SERVICE BULLETIN INDEX

T.S.D. 2933

The following list contains all relevant Service Bulletins issued for the Silver Shadow, T Series, Corniche and Camargue motor cars, between January 1972 and December 1975 inclusive.

Figure 1.

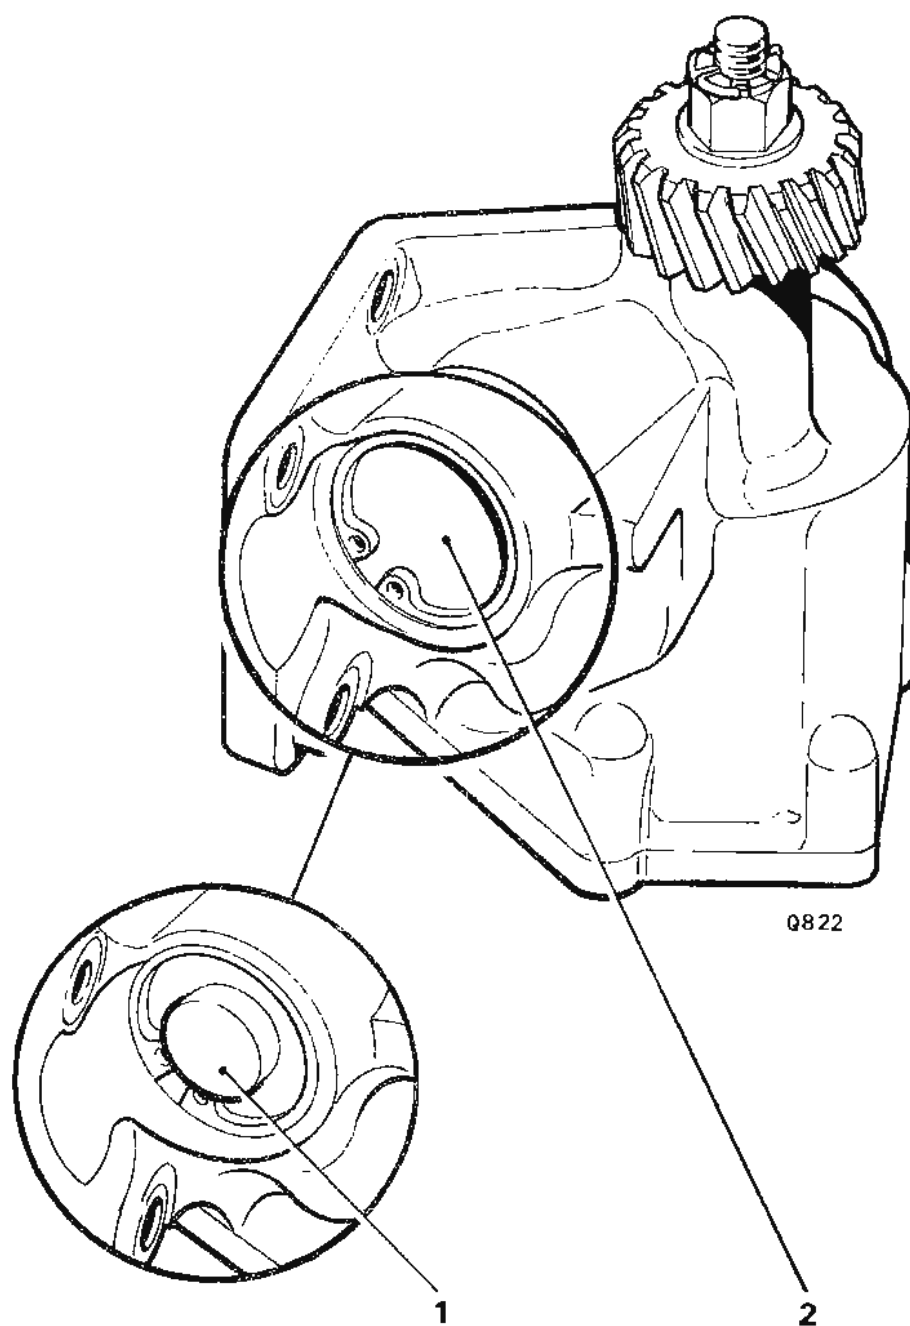
Some little time ago the design of the oil pump relief valve was modified and it was fitted with a slightly different retaining plug. This new plug has a spigot to locate the spring and in contrast to the previous design is flush-faced on the outside. (See Fig 1).

Check by feel or with a mirror the end plug fitting.
(see Figure 1).

Fig.1 Hydraulic pump sealing ring
1 Pump body 3 Plunger
2 Tappet cover 4 Sealing ring
5 Cam follower

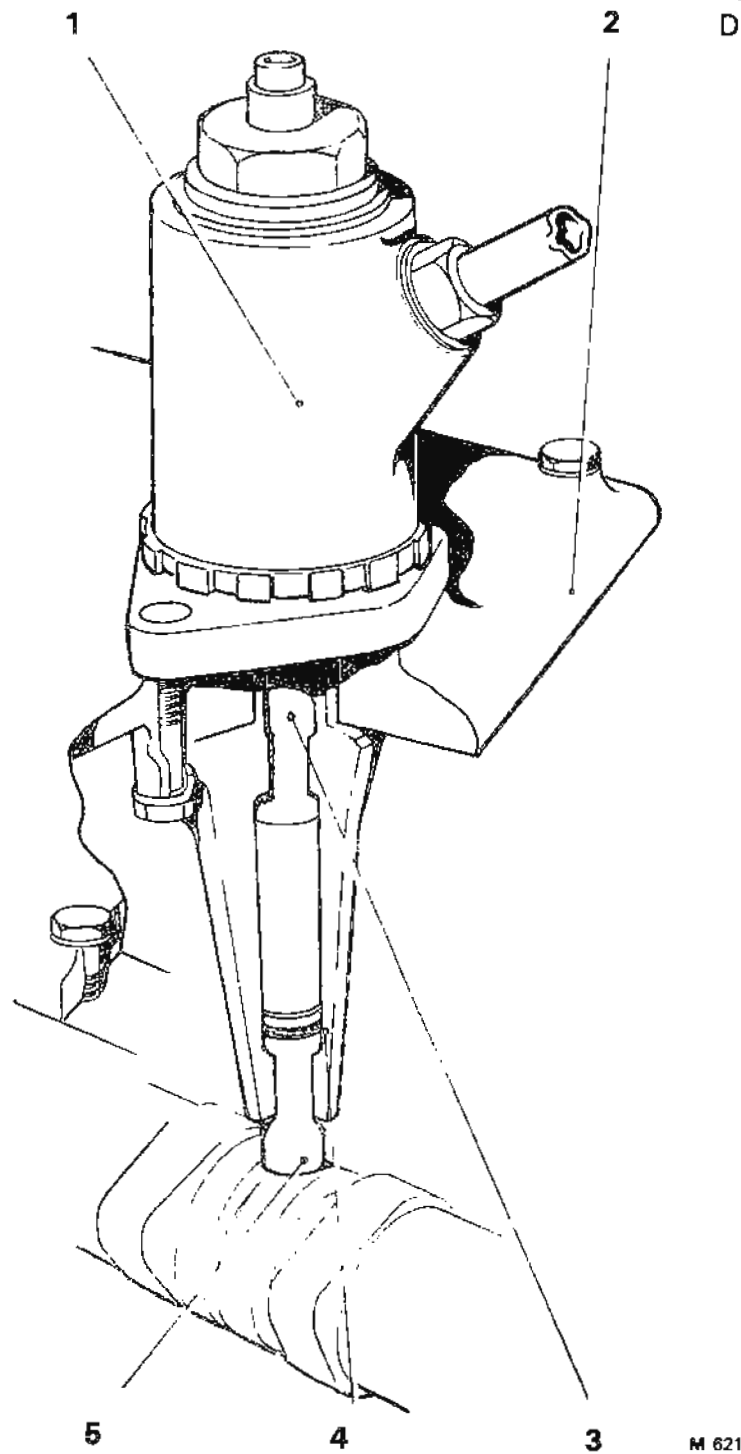
The brake pump cam follower is retained in the bore of the pump push rod housing by a sealing ring, as shown in Figure 1.

Fig. 1 Pipes and Clipping arrangement

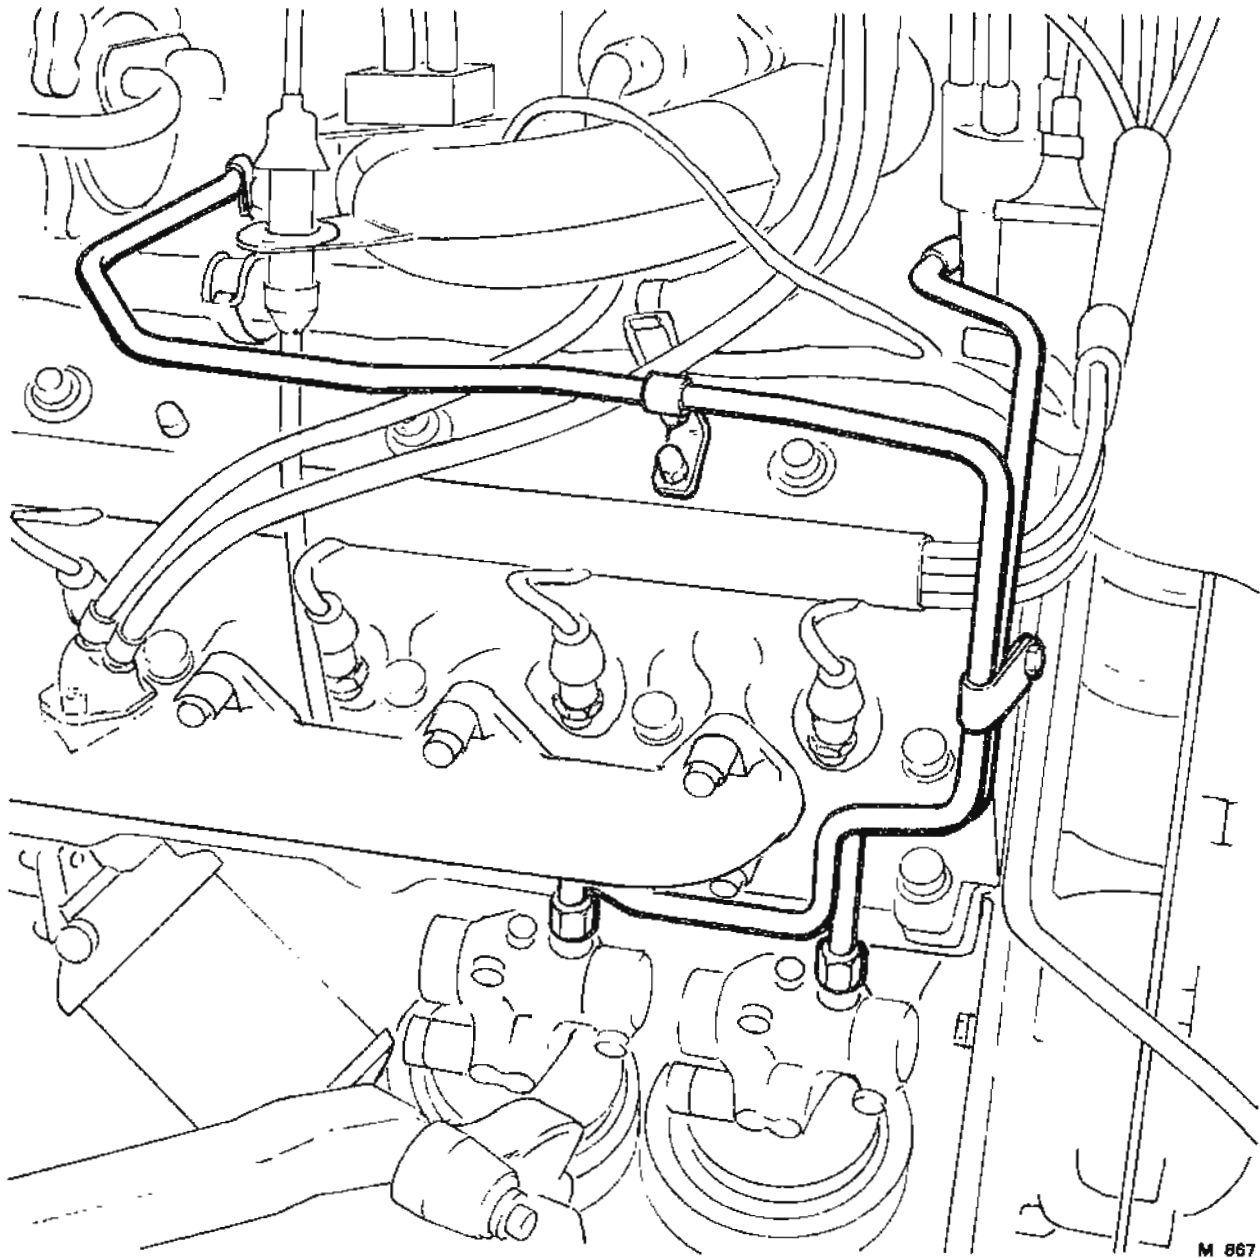
The routing of the new pipes is virtually identical to that followed by the previous pipes and the clipping arrangement is similar. Both the route and clipping of the new pipes are shown in Figure 1.

Figure 1. Low Fluid Level Warning Devices.

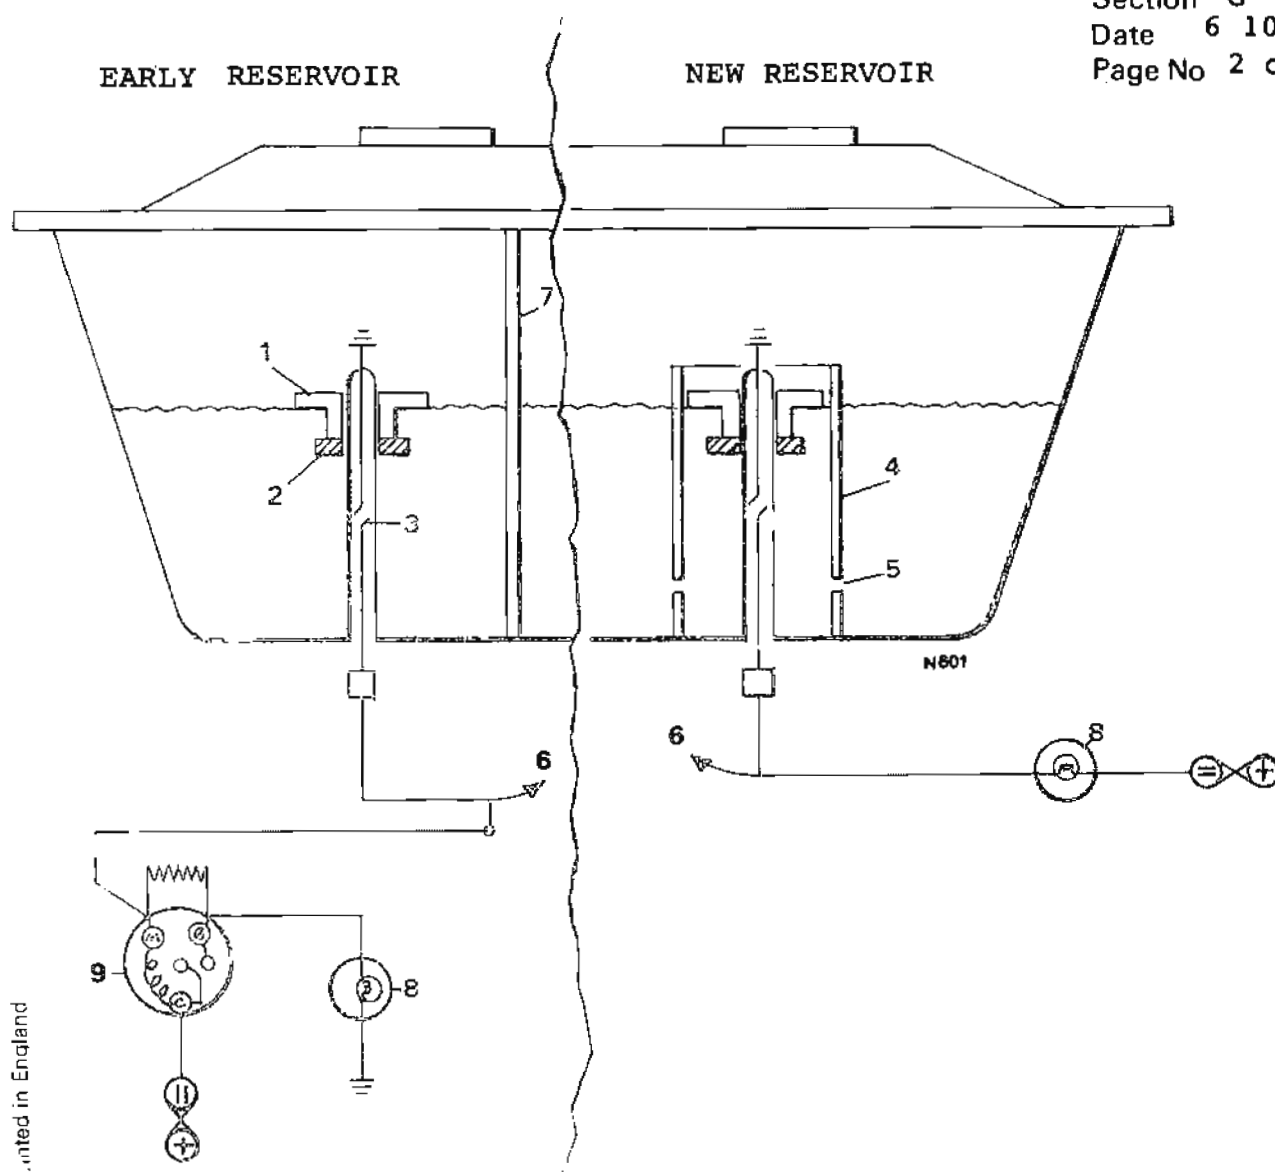
The circuit of the warning lamp is shown in Figure 1.

Fig.3 Theoretical wiring diagram.

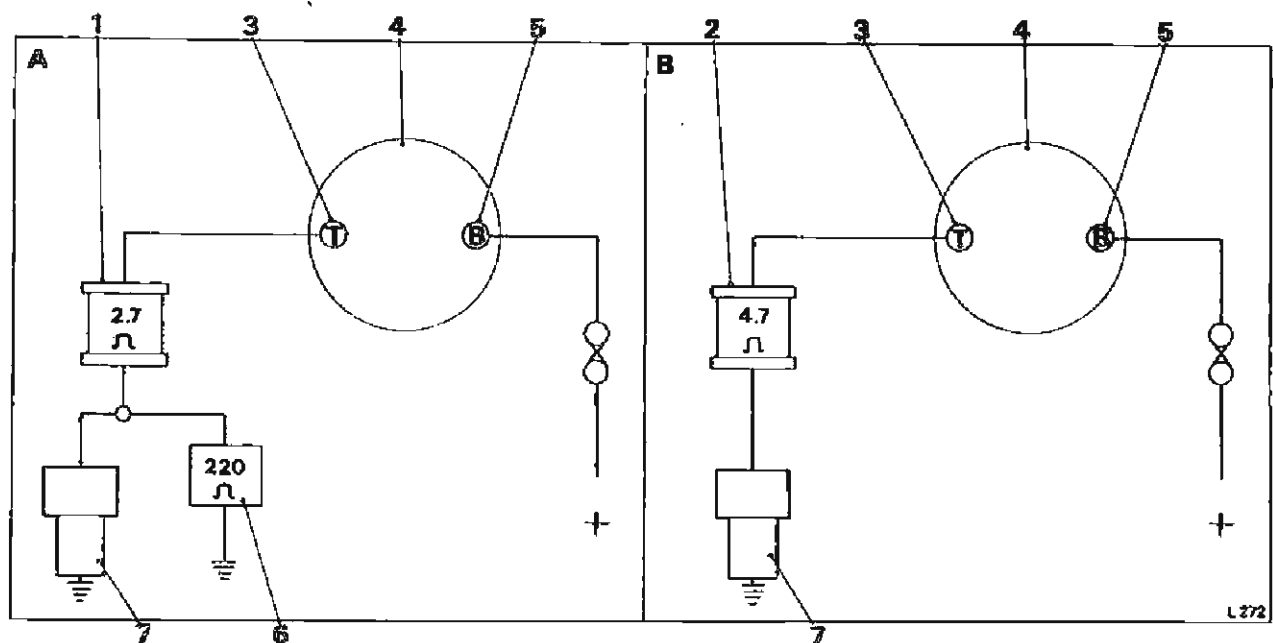
The theoretical circuit diagram for the modification is shown in Fig. 3.

FIGURE 1. FUSE ASSEMBLY

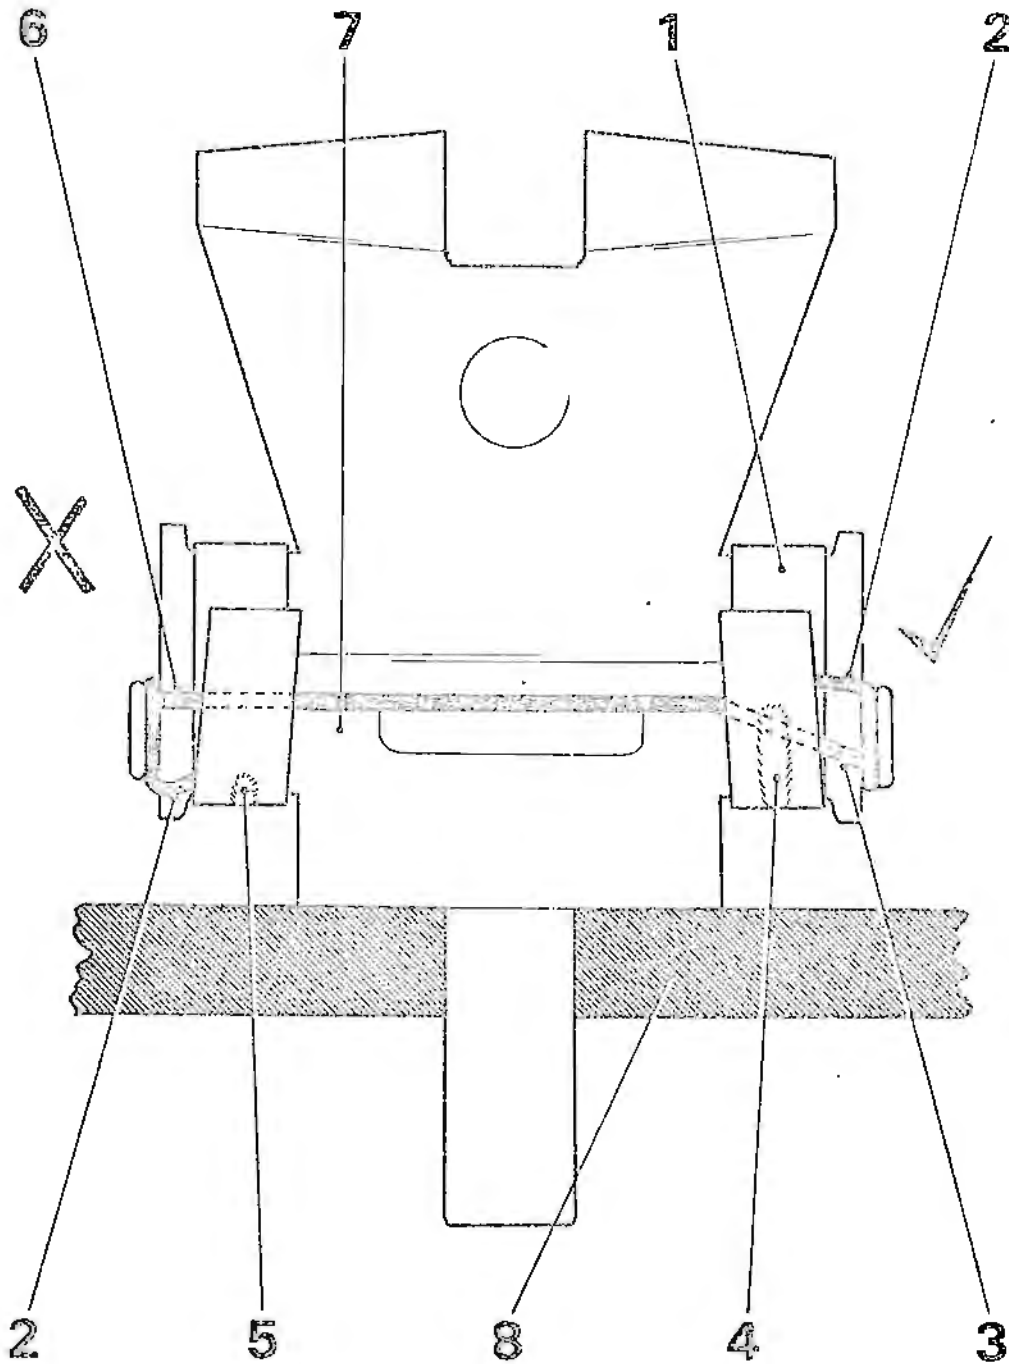
In these cases, the cause of the fuse blowing has been the incorrect mounting of the fuse wire onto the fuse holder as shown in Figure 1, or inadequate clamping of the fuse wire when the fuse is assembled onto the printed circuit as shown in Figure 2.

The correct and incorrect routes for the fuse wire are shown in figure 1.

2. If the blown fuse is wound incorrectly, it should be properly repaired as shown in figure 1. The remaining repairable fuses should also be inspected and corrected if necessary.
3. Remove all six repairable fuses from the fuseboard and disconnect the battery.
4. Using a suitable pair of pliers, squeeze each one of the twelve fuse holders.
5. The holders should be squeezed until the two innermost legs contact each other and then begin to open at the lower end as shown in figure 3.

Figure 1 Revised Circuit

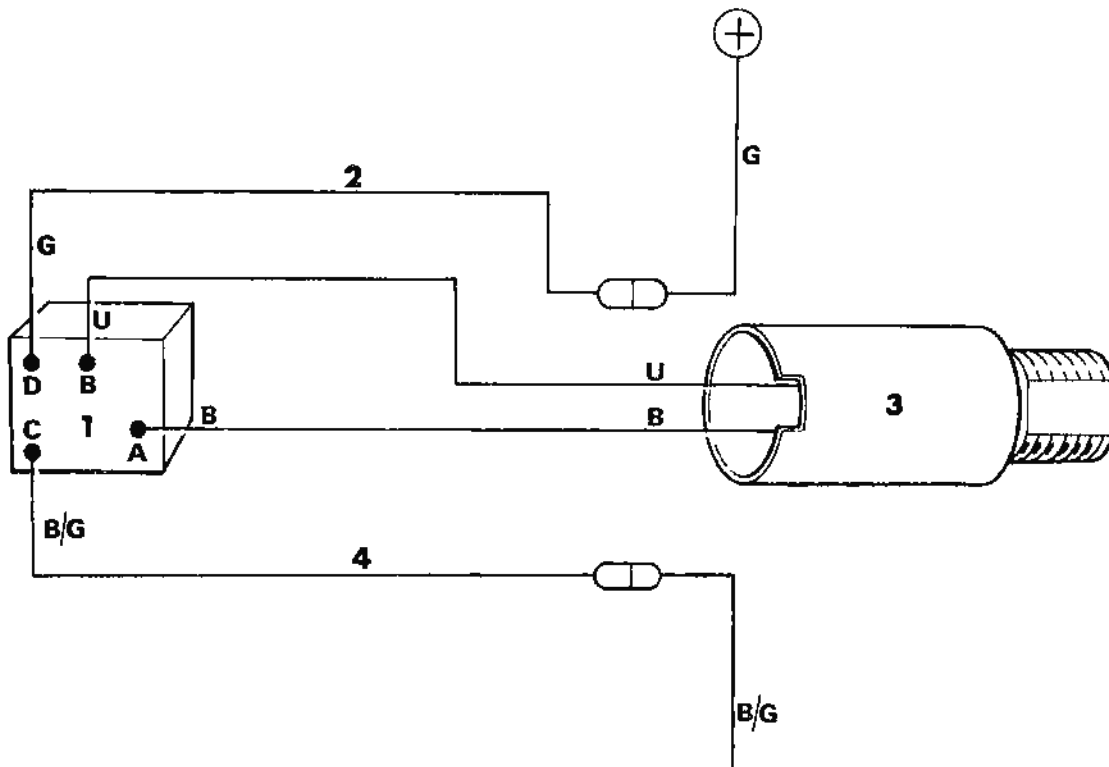
7. Connect the Black and the Blue cables from the original amplifier to terminals A and B respectively as shown in Figure 1.

Fig.1 Theoretical wiring diagram

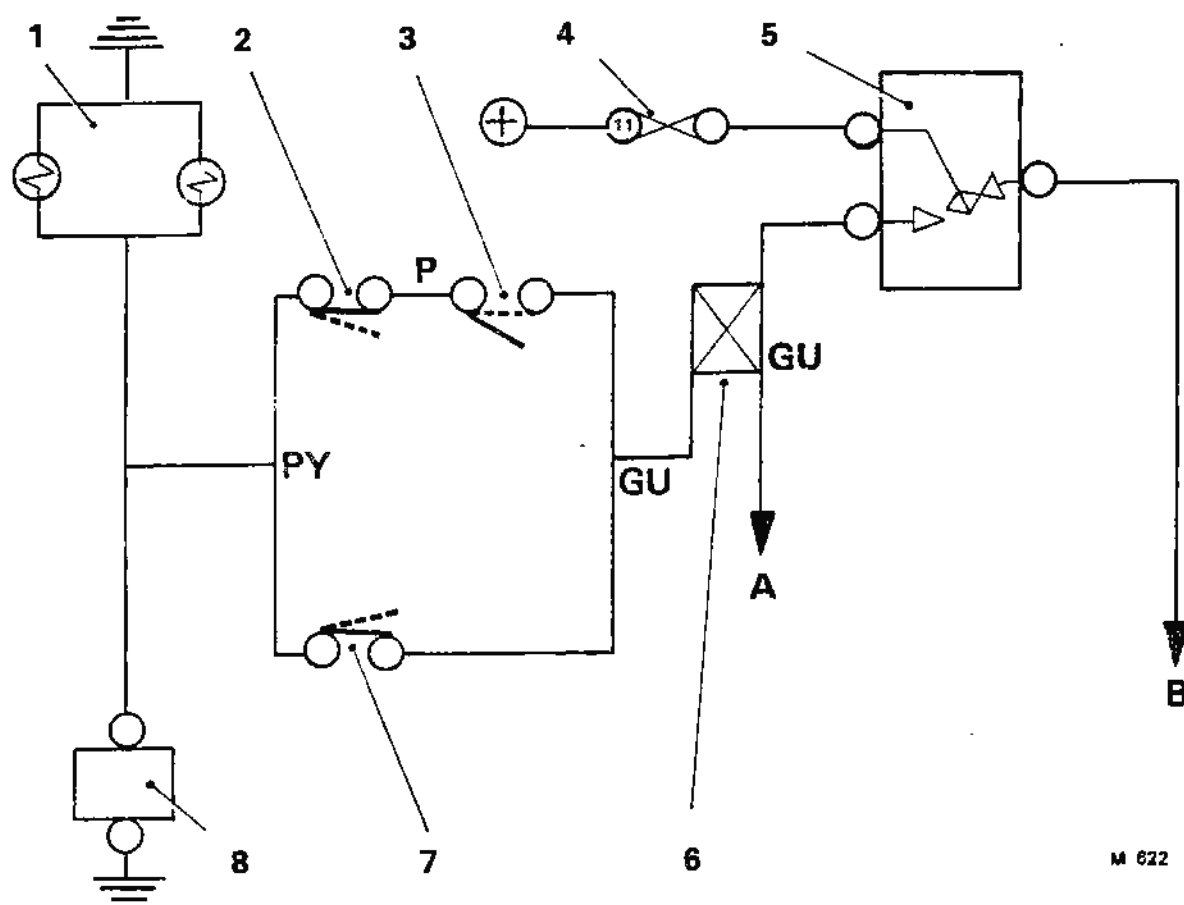
The switch is connected into a circuit which includes a warning lamp on the centre console and a warning 'buzzer'. The circuit is such that if either front seat is occupied, unless the occupant fastens the seat belt, when the gear lever is moved to any of the drive positions the warning lamp will illuminate and the buzzer will sound. A theoretical wiring diagram is shown in Figure 1.
